Engineering Change Request		ECR Number	R10541W
Initiator:	Domen	Date:	2026.07.30
Part number description			
Item	K3 Code material part numbers	Drawing/ Doc Number	Version of current related document
1	See list		
2			
3			
Reason of change: ☐ Customer requirement (list the feasibility analysis of customer specification: _____) ☐ Supplier request (list the PCR number: _____) ☒ internal improvement ☐ corrective ☐ other <u>Please describe here in detail: To improve compatibility with charging sockets and plug holders on the market that are not fully compliant with the J1772 standard, the locking force of the plug's mechanical latch has been increased.</u>			
Change level and impact assessment (Please tick in the appropriate position)			
Change level	Change content	Concerned area(Shenzhen, Hermosillo, Chennai)	Whether to notify the customer
Level 1	☐ Operator change ☐ Correct the clerical errors of the drawing, BOM, etc., and this change will not affect the production process		☐ It is not necessary to notify the customer for approval

To improve compatibility with charging sockets and plug holders on the market that are not fully compliant with the J1772 standard, the locking force of t

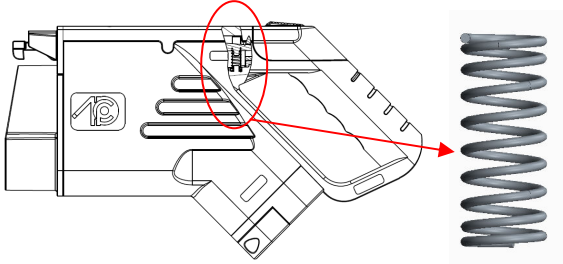
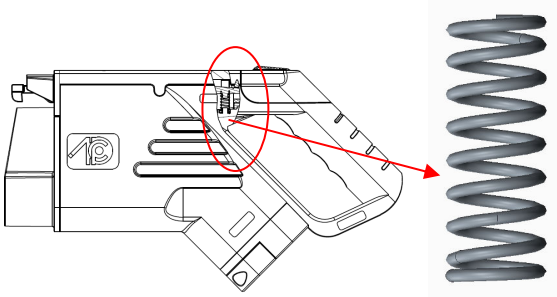
Before change 1./ 	After change 1. Increased Spring Tension 	
Disposition of old materials ☐ Rework ☒ Use as it is ☐ scrap ☐ Other (please describe): _____ ☐ N/A		Expect date to switch to new material
Approval by the supervisor of requester.: <i>Jack Derek</i>	Approval by the head manager of the request dept.: <i>Ching</i>	
Customer approval: ☐ Approved ☐ No approved ☐ Conditional approval (please describe) : Signature: _____ Date: _____		
Remark:
